LINE	QUANTITY	UOP	CAT NO	ITEM NUMBER	UNIT PRICE	AMOUNT
ADDENDUM NO. 04						
ADDENDUM ISSUED TO PUBLISH AND DISTRIBUTE THE FOLLOWING INFORMATION TO THE VENDOR COMMUNITY AS ATTACHED.						
0001	1	LS		968-20		
NEW STATE OFFICE BUILDING IN CLARKSBURG, WV						
***** THIS IS THE END OF RFQ GSD136433 ***** TOTAL:

Addendum Number: No. 04

Addendum issued for the following informational changes and updates.

Clarksburg State Office Building
GSD 136433

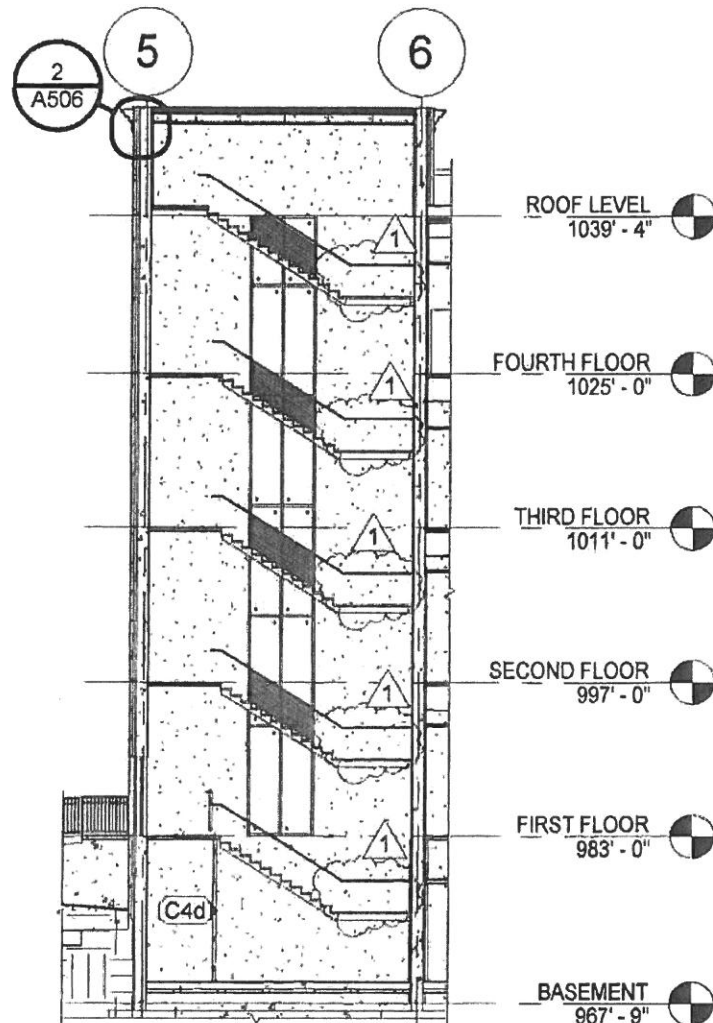
128. Main Lobby Glass @ room 101. Detail 7 on Sheet A502 The detail for ACT Ceiling terminating at glass mullion is not clear as drawn. The bulkhead framing inside room 101 doesn't allow place for Wall Angle and tile to be installed. This detail will work for opposite side of wall which is a drywall ceiling.

A.128. ACT Ceiling termination should be similar to detail 5/A502 with a GYP BD. bulkhead.

REV BY: RJK	ADDENDUM 4	DWG. NO: AD004 1 OF 7
DWG. BY: LRC		RFI NO:
DATE: 2/24/2014		SHEET REF: A401
PROJECT NAME: CLARKSBURG STATE OFFICE BUILDING		PROJECT NO: 0810123.05

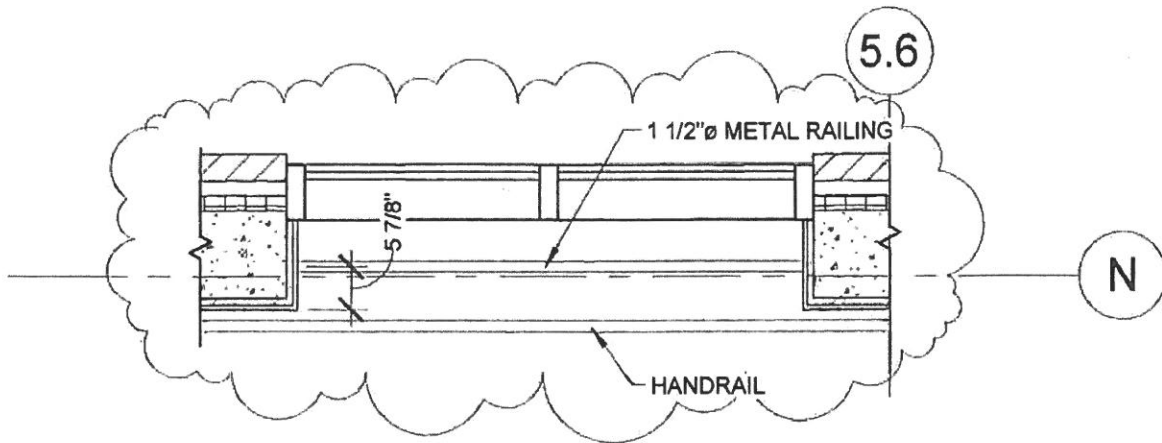
- 3.01** Sheet S505
OMIT: Sheet S505 as found in Issued for Bidding Documents
ADD: Sheet S505 as appended to this Addenda.
- 3.02** Sheet A401 Section A- S1 North Section
Handrails at Intermediate Landings are to be continuous,
See AD004 1 of 7 Appended to this Addenda.
- 3.03** Sheet A401
ADD: Details as shown to clarify Diagonal Fall Protection at Curtain wall inside of Stair towers.
See AD004 2 of 7 Appended to this Addenda.

REVISED S1 NORTH SECTION

REVISED CANOPY FLASHING

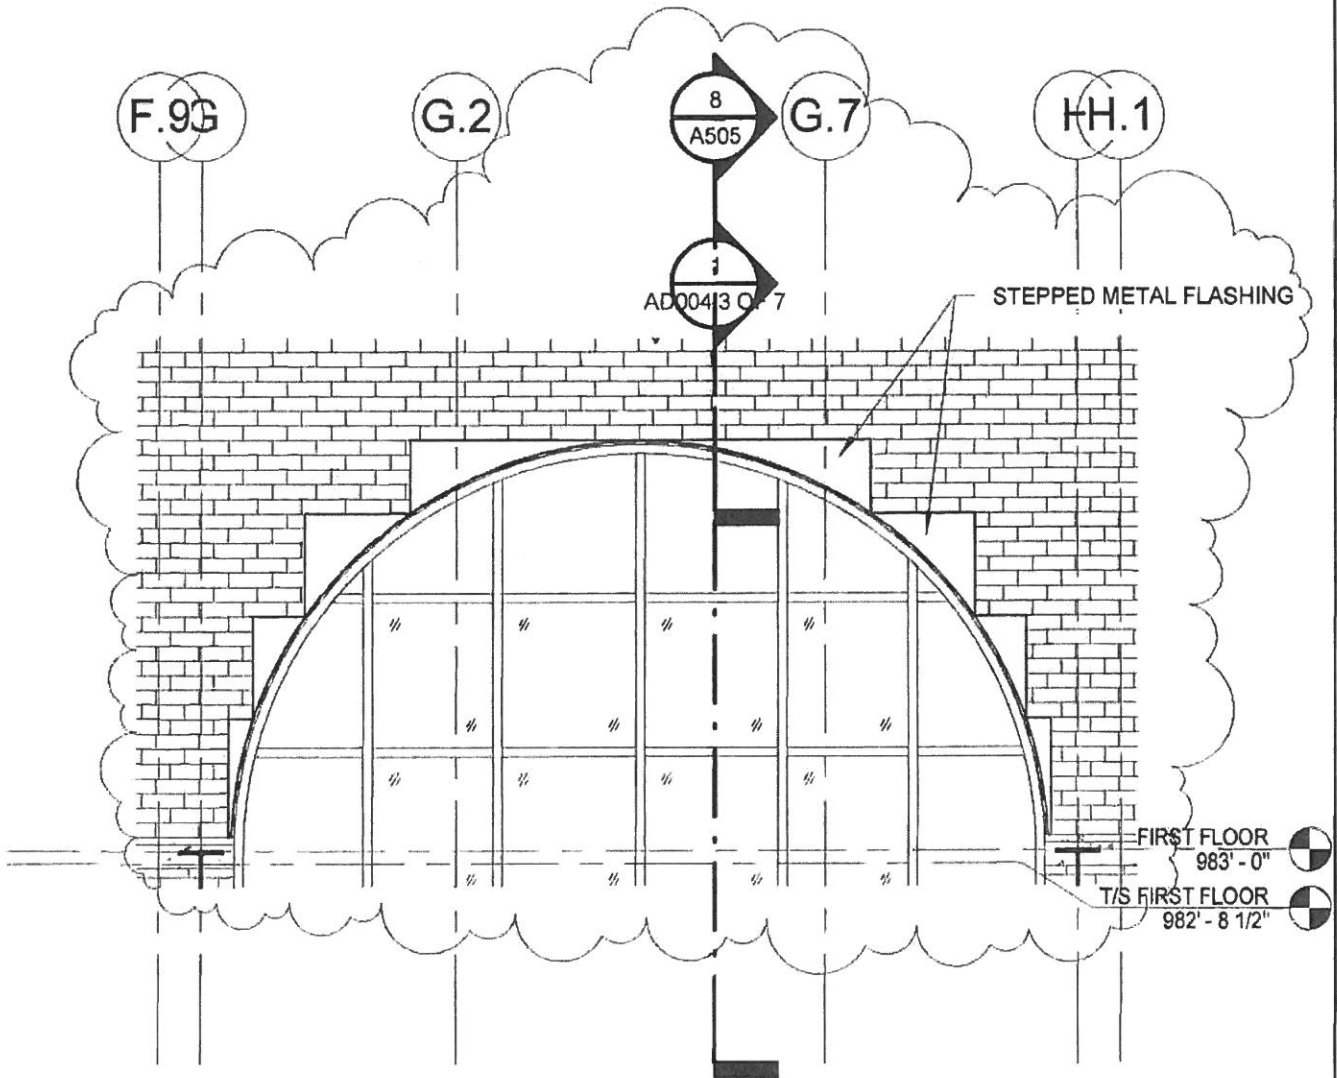
- 3.04** Sheet A402 Elevation 6/A402
REVISED: Step Flashing at Canopy
See AD004 4 of 7 Appended to this Addenda.
- 3.05** Sheet A501
OMIT: Sheet A501 as found in Issued for Bidding Documents
ADD: Sheet A501 as appended to this Addenda.

85. On drawing A202 Detail 7/402 CW3 East Elevation (Interior) cuts a section 8/505 through the curtain wall header. On drawing A505 detail 8 does not show how the wood blocking header is attached to the jambs of the opening. Please supply proper details as to how the wood header will attach to the side jambs

A.85 See this Addendum for drawing AD004, 4 of 7.

406 RECEPTION ENLARGED FLOOR PLAN

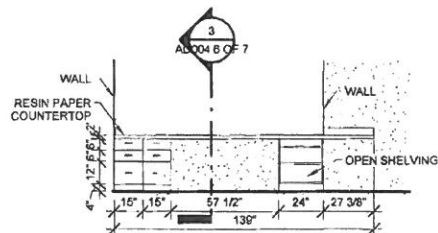
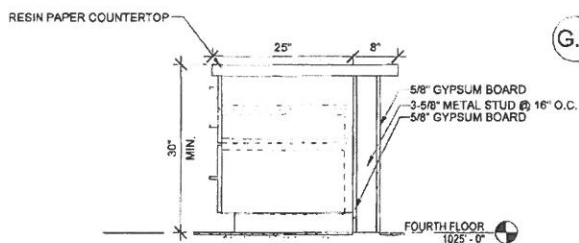
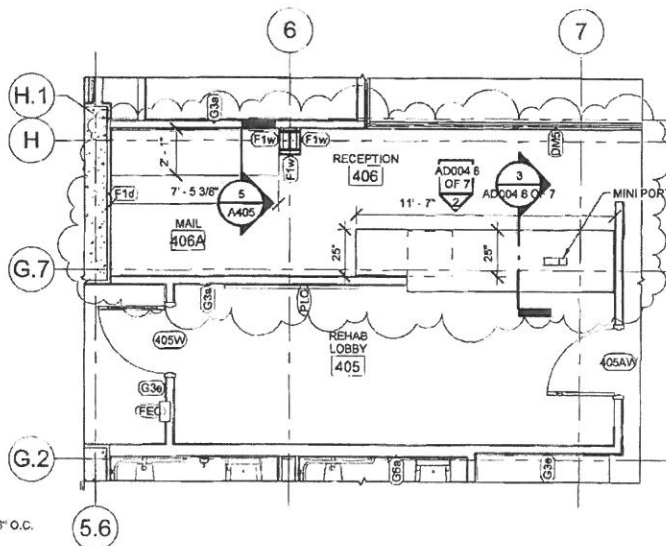
ADD: Enlarged Plan and Casework details for Room 406
See AD004 6 of 7 as appended to this Addenda.

106. On Floor Plan A105, Receiving Room 406 and Mail Room 406A appear to indicate casework. However, there is no elevation view or other indication of what the casework should be. Please advise.

A.106 See this Addendum for drawing AD004 sheet 6 of 7.

FLAGPOLE DETAIL

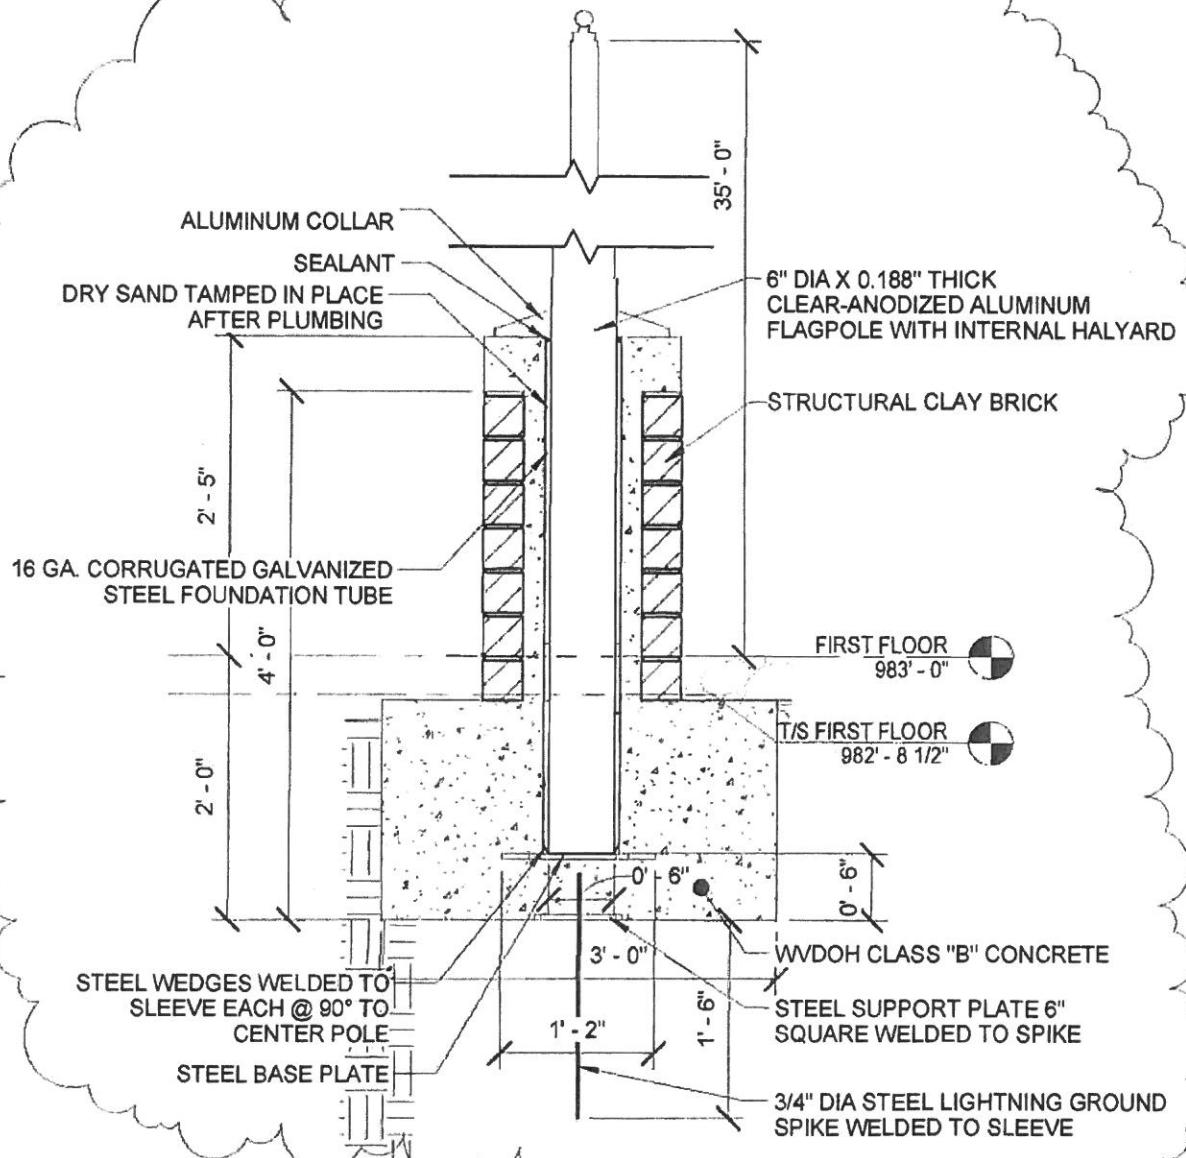
- 3.06** Sheet A504
ADD: Flagpole Detail
See AD004 7 of 7 appended to these Addenda.
- 3.07** Sheet A505 Detail 8/A505
OMIT: Wood Blocking
See AD004 3 of 7 Appended to this Addenda.

2 GOA EMPLOYEE STAIR RAIL
A501 1/2" = 1'-0"

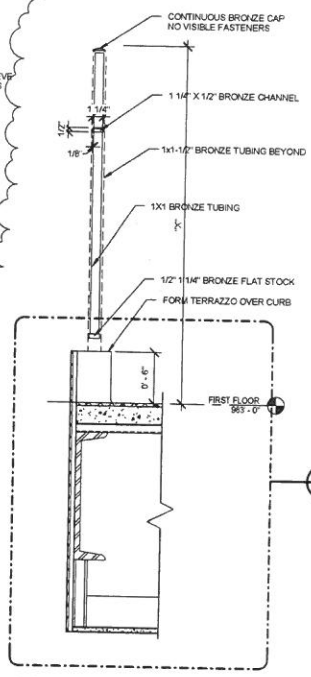
117. Please provide attachment detail for rail to stair stringer and rail to upper platform at employee stair.

A.117. See corrected drawing A 501 in this addenda.

8 MONUMENTAL STAIR RAILING DETAIL
A501 3/4" = 1'-0"

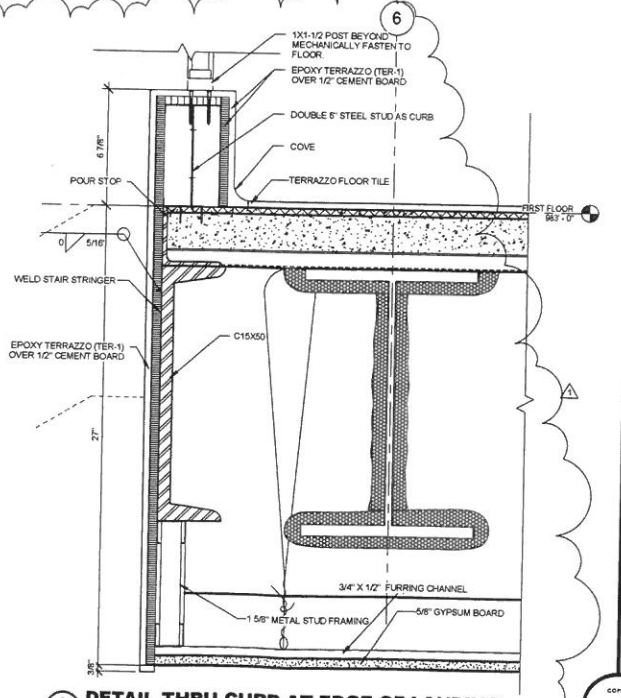
114. Regarding Employee Stair: 5/A501 shows the toe of channel pointed in, and detail 8/A501 shows toe of channel pointed out. Please clarify channel direction.

A.114. See Detail 8/A501 for channel orientation.
